MONTGOMERY COUNTY HISTORIC PRESERVATION COMMISSION
STAFF REPORT

| Address: | 16 W. Kirke St., Chevy Chase | Meeting Date: | 07/26/17 |
| Case Number: | 35/13-17W | Staff: | Dan Bruechert |
| Proposal: | Installation of Fencing | | |

Figure 1: Detail of west fence and gate design

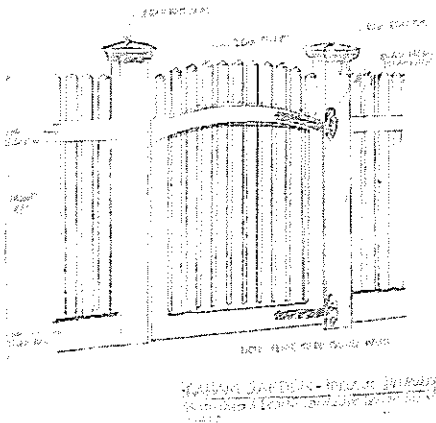
Cedar Picket Fence

The cedar picket fence will be installed in a location that is not visible from the public right-of-

way and is subject to lenient scrutiny based on the *District Guidelines*. The fence is compatible in design and size with the requirements of the *Design Guidelines* and is consistent with the surrounding historic district. There will be a centrally located gate to provide access from the driveway into the back yard (details below). The fence complies with all of the adopted guidance and should be approved.

Figure 2: Proposed side fence design

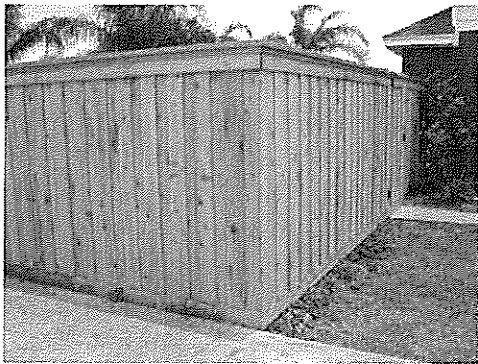
Along the western property boundary, the applicant is proposing to install a board on board 6' (six foot) privacy fence and gate. As a portion of this fence will be visible from the public right-of-way *District Guidelines* dictate that its review be given moderate scrutiny. As the fencing will only abut the historic house and not attach to it, the proposed fencing will not impact the house's ability to continue to contribute to the historic district. Cedar is an appropriate material and is consistent with the surrounding district.

The fence and gate, however, extend beyond the rear wall plane and contravene the adopted fencing guidance. The *Design Guidelines* state that fences in front of the rear wall plane should not be taller than 48" (forty-eight) inches. Due to the flat topography of the building site, Staff supports either the lowering of the fence in front of the wall plane to no higher than 48" (forty-eight inches) or the relocation of the gate to the southeast corner of the sunroom so the fence is co-planer to the rear wall plane. Either of the identified changes would bring the proposed fence into compliance with the *Design Guidelines*, specifically sections 12.3 and 12.4.

The location of the proposed 6' (six foot) tall cedar privacy fence will also visually enclose much of the right side of the house. By enclosing this space there will be a negative impact on the desired open, 'park-like setting' identified in the *District Guidelines*. The 'park-like setting' of the district would be better served by either lowering the fence to a height no taller than 48" (forty-eight inches) in front of the rear wall plane or relocating the 6' (six foot) tall fence and gate so that the construction does not extend beyond the rear wall plane. Staff recommends the cedar privacy fence be approved with the condition that either it be lowered in its current location or that the fence and gate be relocated behind the rear wall plane. Staff has discussed these alternatives with the applicant, but the applicant has not identified a preferred alternative.

1. The 6' (six foot) tall cedar fence proposed for the left side of the house does not comply with adopted fence guidance. The fence and gate must either be lowered to a height of no more than 48" in front of the rear wall plane or the fence and gate may not extend forward of the rear wall plane. Revised plans must be submitted for review and approval with final approval authority delegated to staff.
